Engineering Report

- **Onsite Wastewater Management System**

Lot 1, D.P. 416509, South East Bay, Pelorus Sound

Subject: Delport – South East Bay Pelorus Sound – U130496 – Further Information
Our ref: 3967

DRAWING
SITE LAYOUT

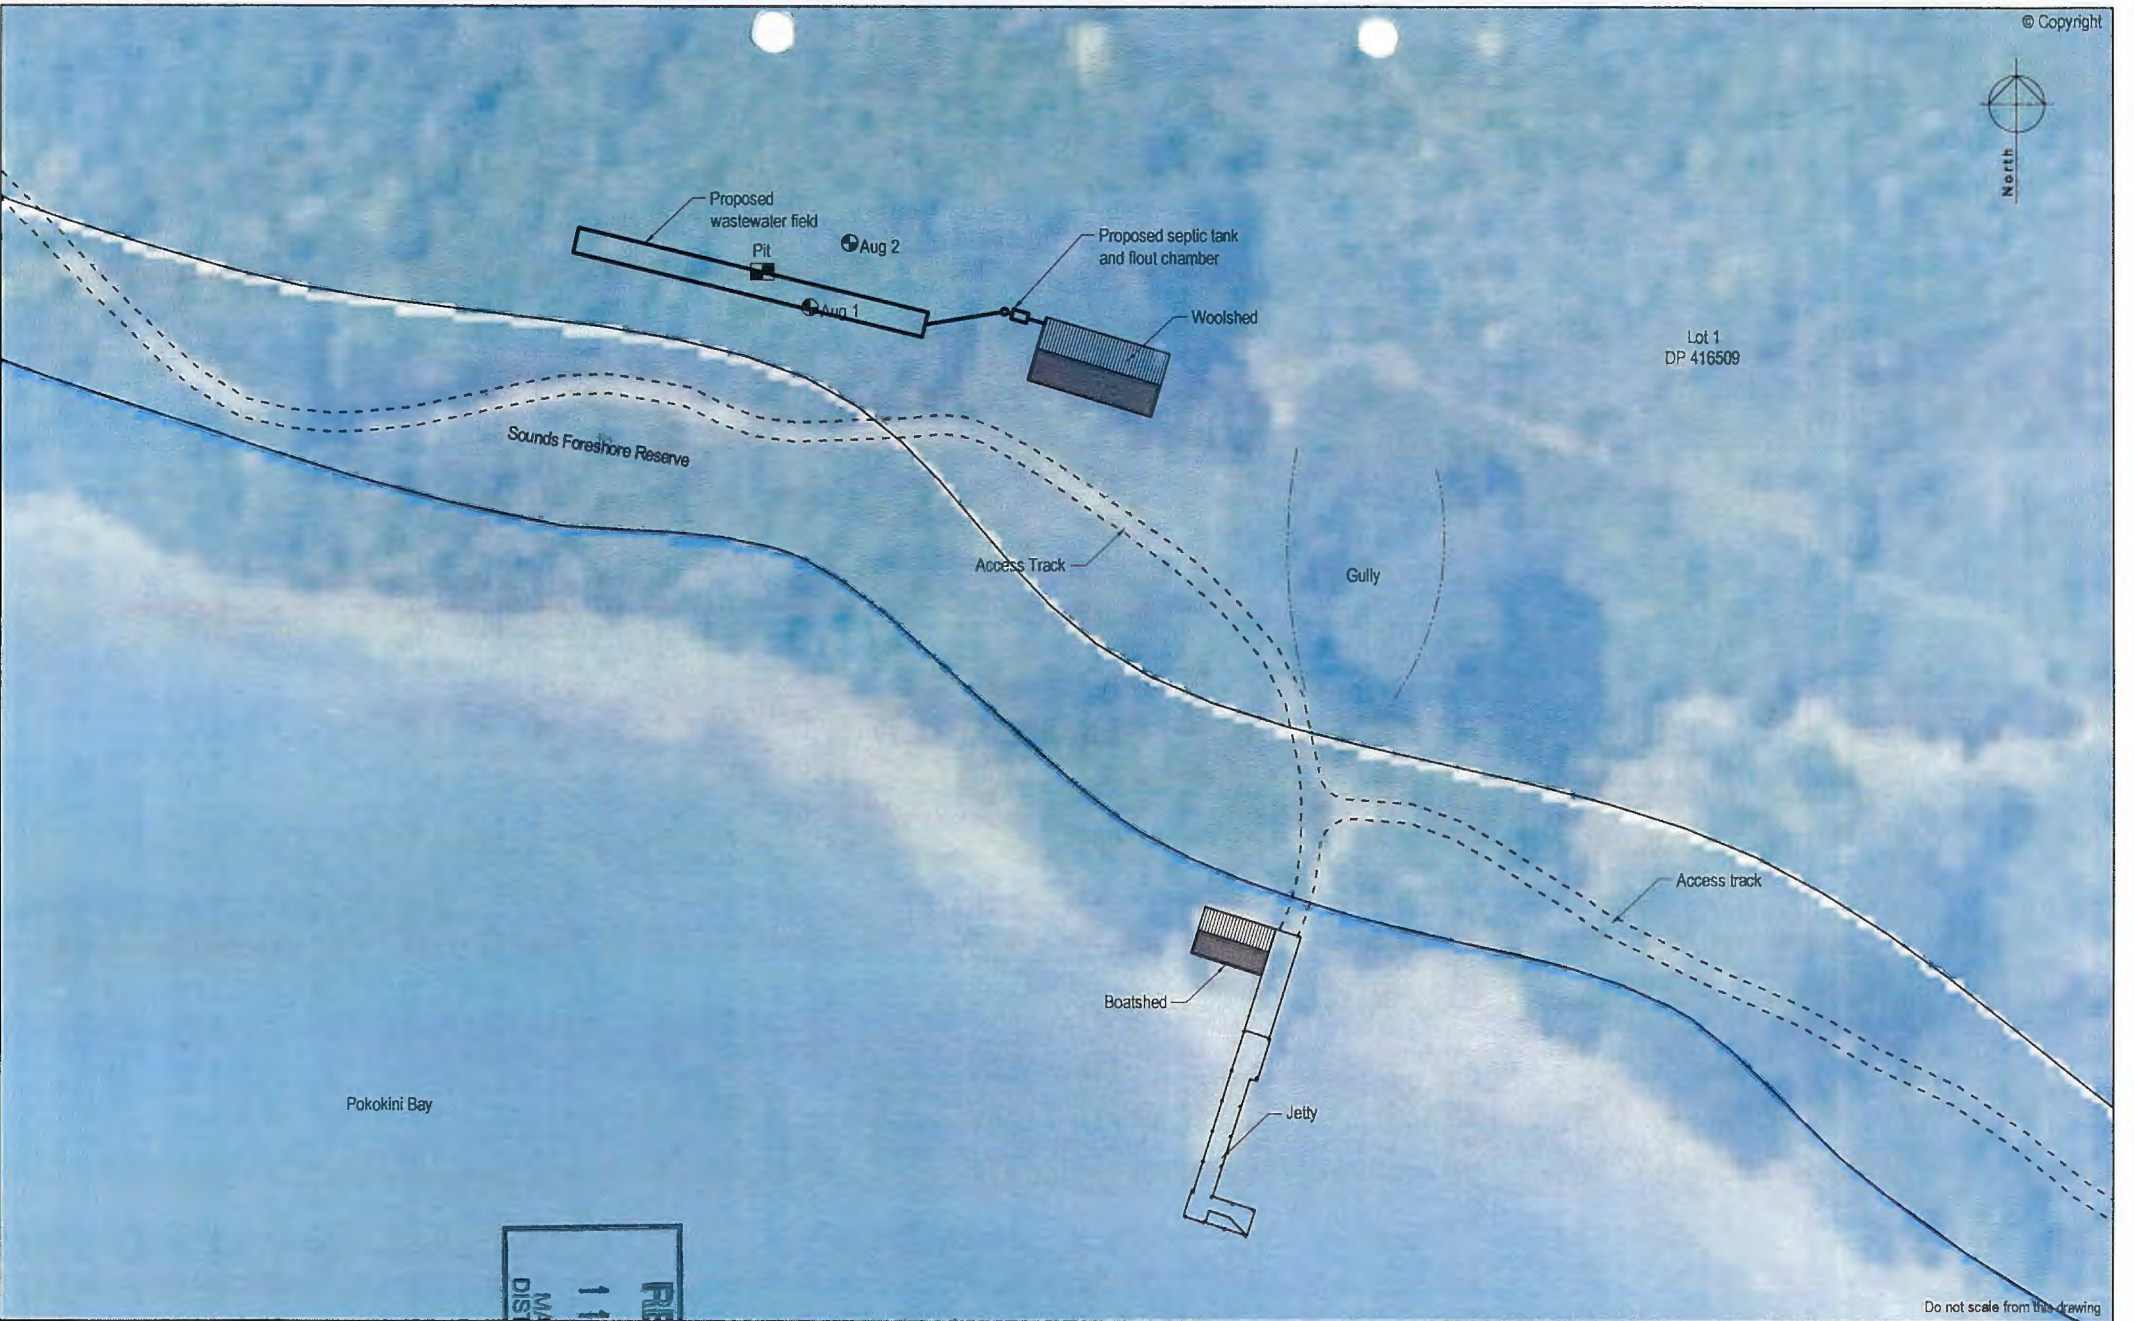
4. **Provide a plan showing the footprint of the new 2nd dwelling in relation to the former woolshed.**

The 2nd dwelling is proposed to be fully accommodated within the envelope of the existing woolshed. Decking is proposed to be attached around the outside of the existing building. The plans attached to the application illustrate this.
